Access Compliance Report Public Rights-of-Way (Curb Ramps)

Main Street: WASHINGTON_AVE		Cross Street: RIATA_ST		Location:	NW
ADA ID: RPRK220203133558	Ramp Type: Type 4 - Parallel	Initial Pass/Fail: Pass	Overall Compliance: No	Severity Score:	0
Codes/Mitigation Info/Possible Solution			Field Measurements/Component Compliance

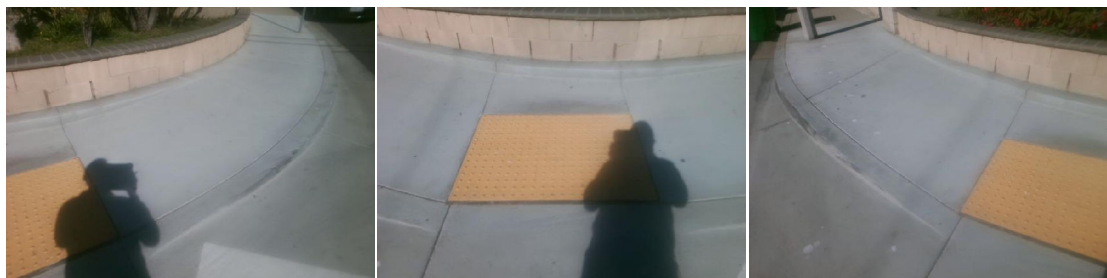
R304.2.2-Perp, R304.3.2-Para, STD 1115

Remove & Replace Landing.
